# NPP Fennovoima

Expert Statement to the EIA Report

Ordered by the Federal Ministry for Agriculture, Forestry, Environment  
and Water Management, Project Management Department V/6  
"Nuclear Coordination"

REPORT  
REP-0196

Figure 1: Example of deposition of Cs-137 over Europe resulting from a hypothetical severe accident in the new NPP at Kampuslandet (near Loviisa), assuming a release of 25,500 TBq in the hour after 1995-07-28 06:00. Output grid size is 1°.

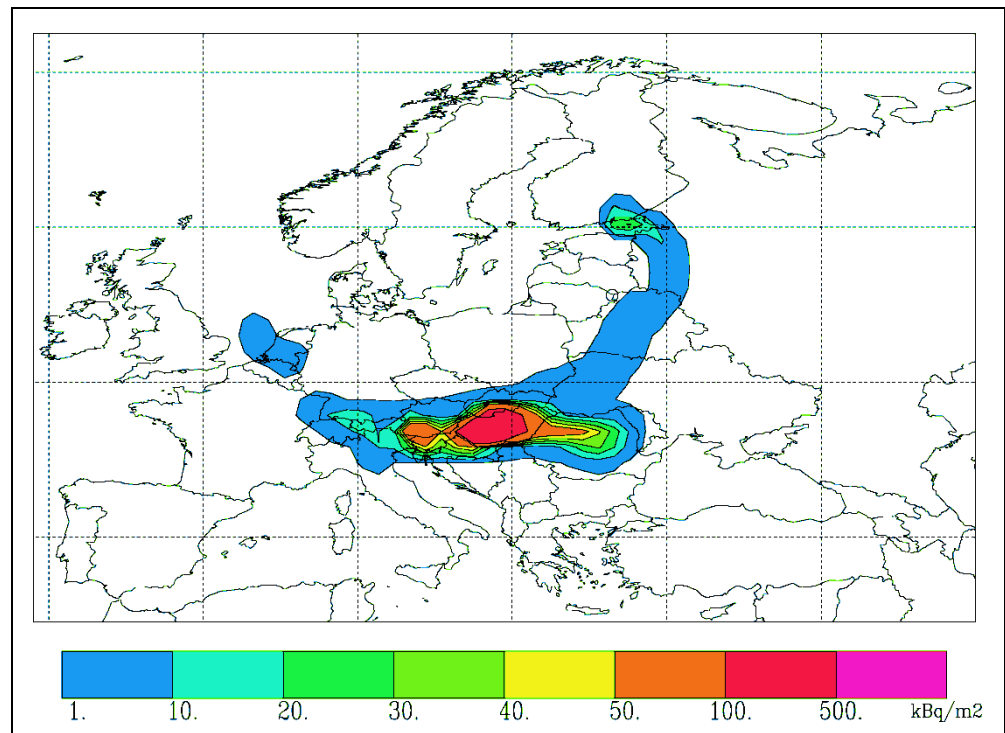
The figure shows a worst-case scenario for Austria and Hungary, where the south of Austria would receive a deposition above 50 kBq Cs-137/m<sup>2</sup> on a larger area, and almost all of Hungary would be contaminated higher than 100 kBq/m<sup>2</sup> Cs-137. During spring and summer food bans and restriction in stock farming would be necessary if such a situation were to become reality.

If a deposition of 50 kBq/m<sup>2</sup> is exceeded in Austria as it is indicated in figure 1, during spring and summer food bans and restriction in livestock farming would be necessary if such a situation were to become reality. 50 kBq/m<sup>2</sup> correspond to an effective dose of 2.5 mSv for the first year, which implies the Austrian warning scale level 2 requiring protection measures for children, expectant and breast-feeding mothers (RAHMENEMPFEHLUNGEN 1992). The new order for intervention in radiological emergencies (INTV 2007) recommends sheltering for risk groups if an effective dose of 1 mSv in seven days could be exceeded. Because the largest part of the dose will be received in the first week after an accident it cannot be excluded that the intervention limit for seven days could also be exceeded.

Figure 2: Core damage frequency for the considered reactors.

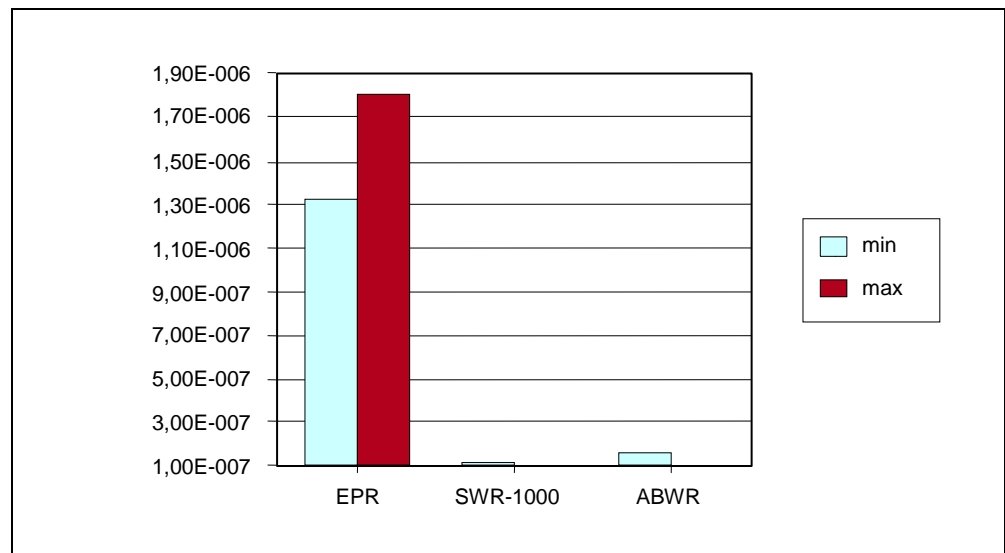
For the EPR, CDF values of 1.33–1.8E-06/a are reported; for the ABWR, 1.6E-07/a; and for the SWR-1000, 1.1E-07/a. CDF is to be lower for the AB1600 than for earlier ABWR designs; however, no PSA results appear to have been published so far.

The LRF for the EPR is reported as 1.0E-07/a, whereas for the ABWR, a value of < 1.0E-09 is given. No published LRF value for the SWR-1000 could be found.

Figure 3: Example of deposition of Cs-137 over Europe resulting from a hypothetical severe accident in the new NPP near Loviisa, assuming a release of 25,500 TBq in the hour after 1995-07-28 03:00. Output grid size is 1°.

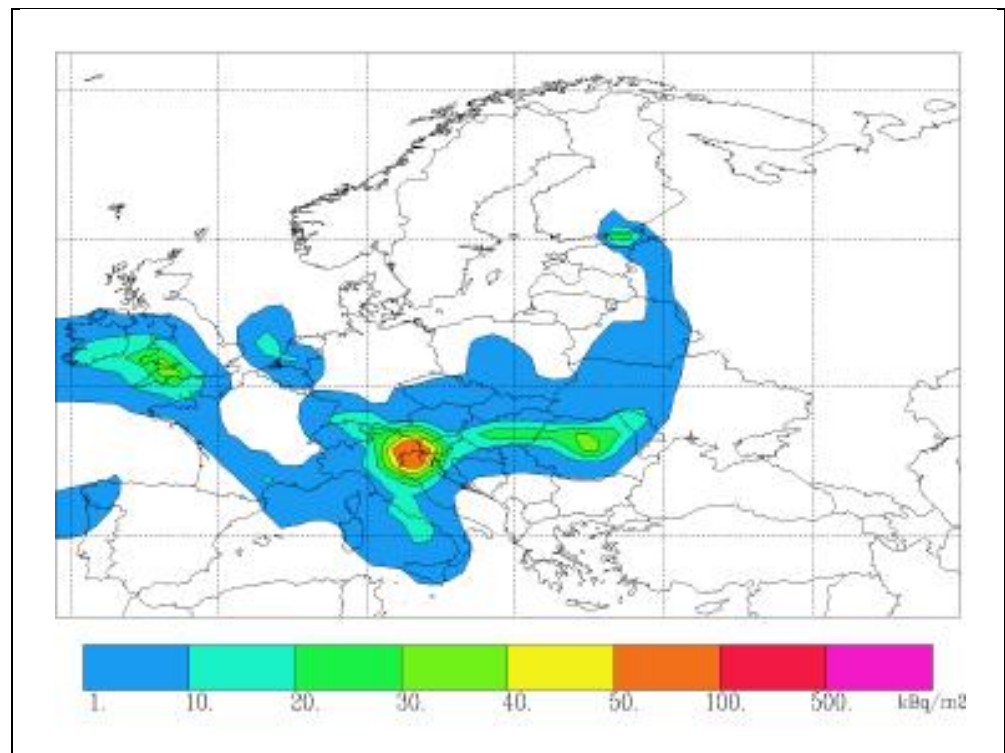
For a release from Loviisa on 28 July 1995 around 03 UTC (figure 3), we find a contamination band extending southeastward from the site through Russia, Belarus and Ukraine into Romania. In Romania, the intensity of the deposition increases from below 10 to around 30 kBq/m<sup>2</sup>, an indication of transport in dry weather first and then coming under precipitation causing wet deposition.

This change in the weather is also marked by the change in the transport direction, first southward with northerly winds, then westward with easterly winds. The contaminated air arrives then over northeastern Italy where intensified precipitation would cause contamination of up to 66 kBq/m<sup>2</sup>. This contamination area would include southern and western Austria with values between 20 and 50 kBq/m<sup>2</sup>. Then

Figure 6: Example of deposition of Cs-137 over Europe resulting from a hypothetical severe accident in the new NPP at Kampuslandet (near Loviisa), assuming a release of 25,500 TBq in the hour after 1995-07-28 06:00. Output grid size is 1°.

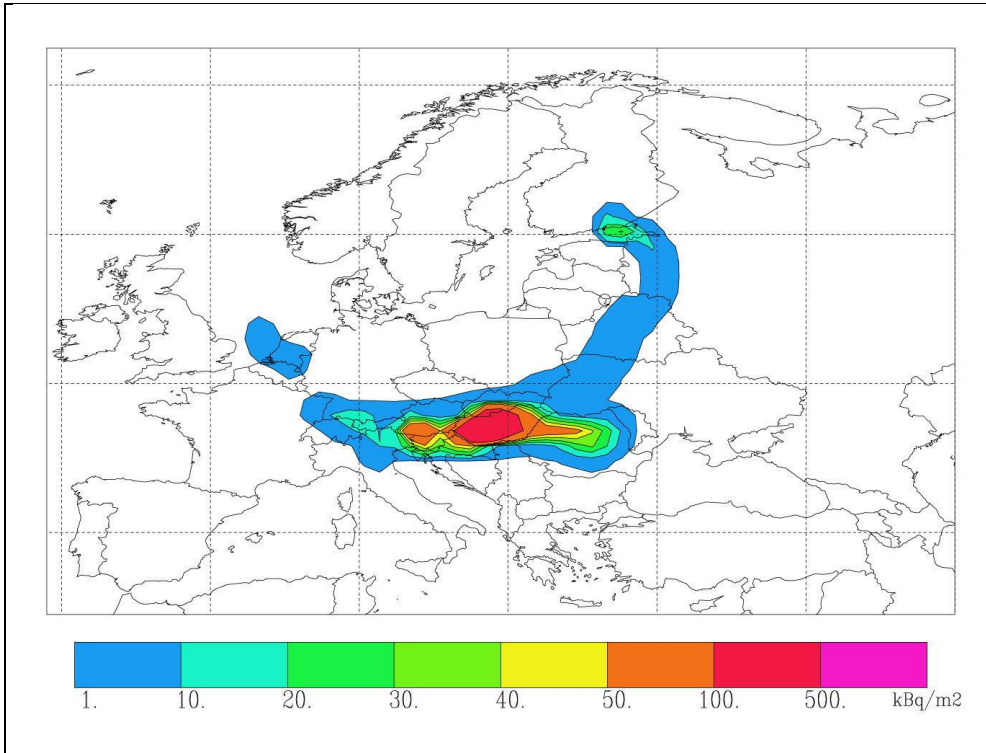
If the release at Kampuslandet is assumed 3 hours later (figure 6), the south of Austria would receive above 50 kBq/m<sup>2</sup> on a larger area, and almost all of Hungary would be contaminated above 100 kBq/m<sup>2</sup>. With a slightly different weather pattern, such contamination could also hit the eastern part of Austria. Also with releases on 30 July contamination of large parts of Austria is simulated. In the case of a release at 09 UTC, the centre of contamination would be in Czech Republic and touch the north of Austria.

If a deposition of 50 kBq/m<sup>2</sup> is exceeded in Austria as it is indicated in figure 6, during spring and summer food bans and restriction in livestock farming would be necessary if such a situation were to become reality. 50 kBq/m<sup>2</sup> correspond to an effective dose of 2.5 mSv for the first year, which implies the Austrian warning scale level 2 requiring protection measures for children, expectant and breast-feeding mothers (RAHMENEMPFEHLUNGEN 1992). The new order for intervention in radiological emergencies (INTV 2007) recommends sheltering for risk groups if an effective

Figure 7: Example of deposition of Cs-137 over Europe resulting from a hypothetical severe accident in the new NPP at Hanviki, assuming a release of 25,500 TBq in the hour after 1995-07-30 03:00. Output grid size is 1°.

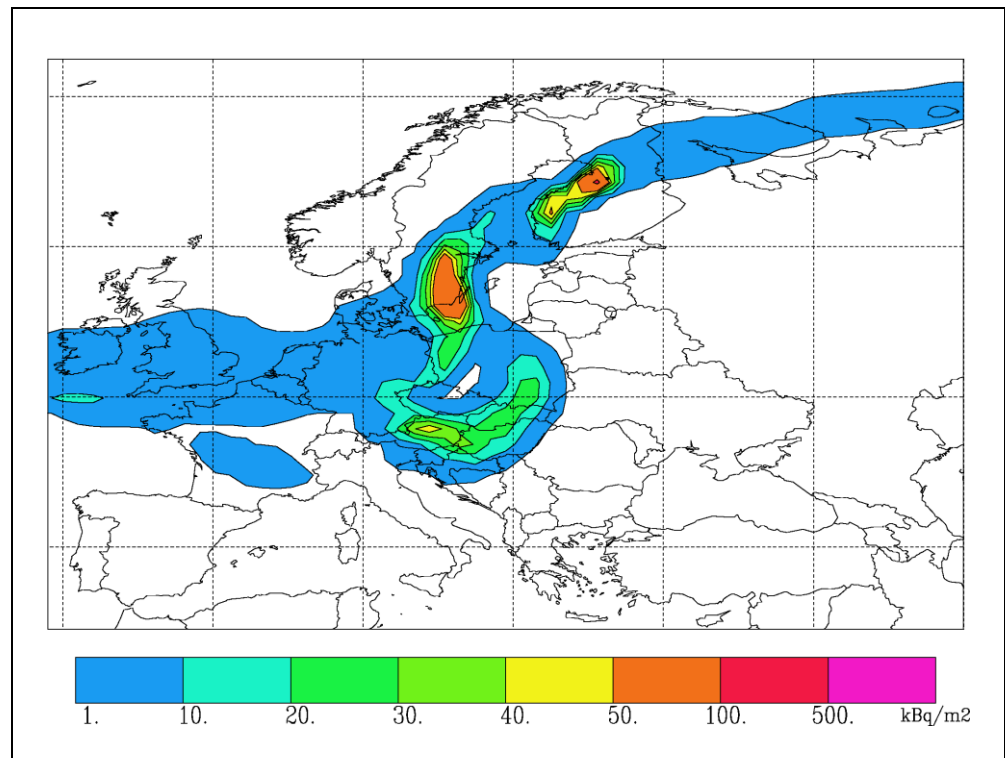
At the more northern site of Hanhikivi, a release on 30 July 1995 at 03 UTC was found to have the most negative consequences for Austria (figure 7). The central part of the country would be contaminated with more than 40 kBq/m<sup>2</sup> and the whole area to the east of the line Salzburg – Klagenfurt would be contaminated with more than 10 kBq/m<sup>2</sup>.

Figure 8: Example of deposition of Cs-137 over Europe resulting from a hypothetical severe accident in the new NPP at Karsikkoniemi, assuming a release of 25,500 TBq in the hour after 1995-07-29 15:00. Output grid size is 1°.

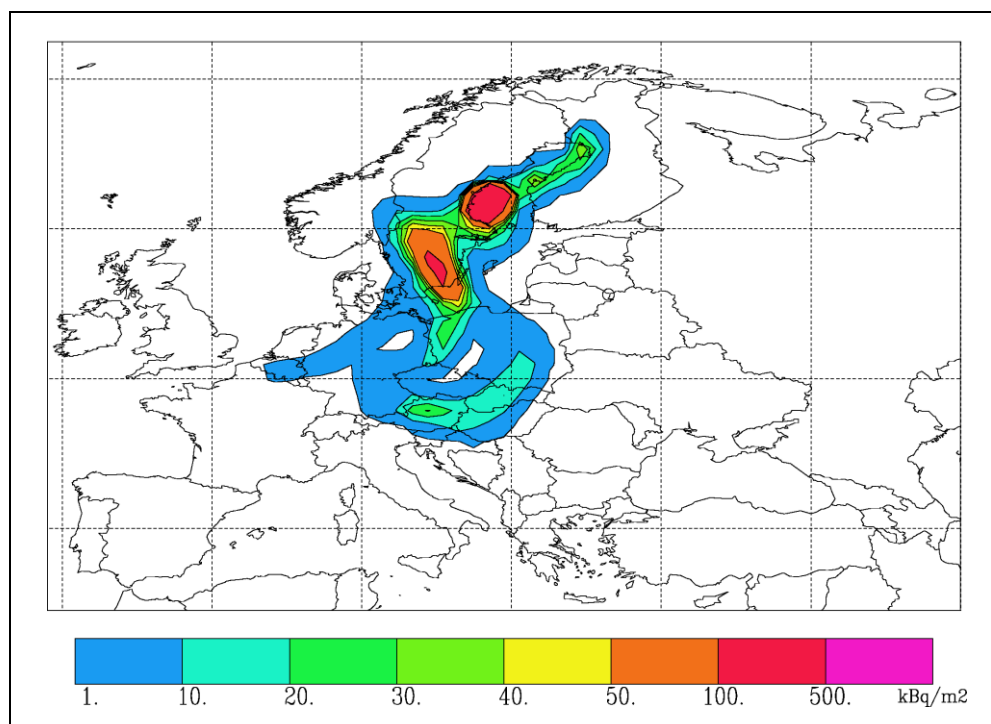
Finally, for the northernmost site Karsikkoniemi two dates with similar impact on Austria were found in the investigation period, with releases on the 28<sup>th</sup> at 21 UTC and on the 29<sup>th</sup> at 15 UTC, July 1995. Both lead to contamination between 10 and 30 kBq/m<sup>2</sup> in the eastern part of Austria, the first one more in the south, the second one more in the north (figure 8).
